We would like to thank the referee for the helpful comments, as well as for the time and effort invested in the review. Below we provide our response to the reviewer's comments and describe the modifications made to address them. In black font we include the reviewer's comments, and in blue is our response.

Figure R1: Frequencies of "Birth", "Death", "Merge", "S plit" and "Track" categories relatively to the total number of tracked rain cells for each synoptic type.

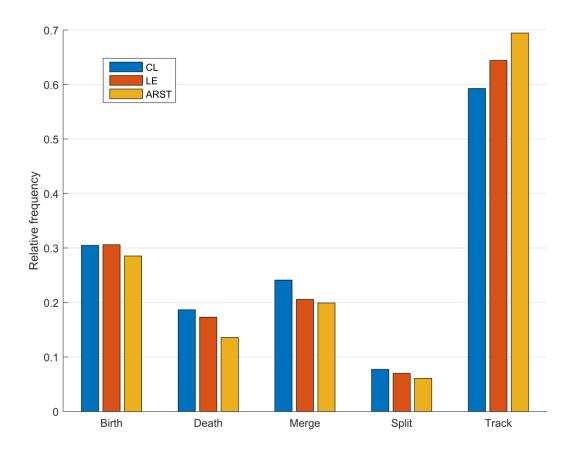
"...nor properties related to these cells "counts" such as mergers (i.e. collisions of cells) and cell splits. It seems that multicell storms, as well as the dynamics of these cells would be important (and indeed are in other climate regimes), and so the authors should at least justify omitting such analysis and, if appropriate, include it. Differences, if any exist, between the different synoptic regimes would be interesting to see"

Thank you for raising this important issue. We bring here this calculation in Fig. R1. The five possible categories in each track are displayed in the x axis, and the average relative frequency of each category is displayed in the y axis for the different synoptic types. The relative frequency is calculated for each storm event and each category by dividing the number of category occurrences in the number of tracked rain cells during the storm. The values that are displayed in the y axis are the average taken for these relative frequencies of the storms. Five categories are considered: Birth - a rain cell was created at time t, Death – a rain cell at time t was not detected at time t+1, Merge - at least two rain cells at time t were merged into one cell at time t + 1, Split - a rain cell at time t was split into at least two cells detected at time t + 1, Track - a rain cell at time t was detected along the motion vector at time t + 1.

It can be seen that the ARST events have on average more cells tracked than the other synoptic states, which corresponds with the higher average lifetime of these cells. Though some differences between the synoptic systems do exist in the relative frequency of the above mentioned categories (significant differences were found between the relative frequency of the "Track" category of the CL and LE as well as the ARST and the CL), we believe that adding this analysis have no added value for the paper. A justification for omitting this analysis is given in the revised manuscript in p5 line 14:

"Frequencies of different tracking categories during the cell's full life cycle (i.e., frequency of splits, merges and etc.) were left out of the analysis, as no added value to the presented results was given".
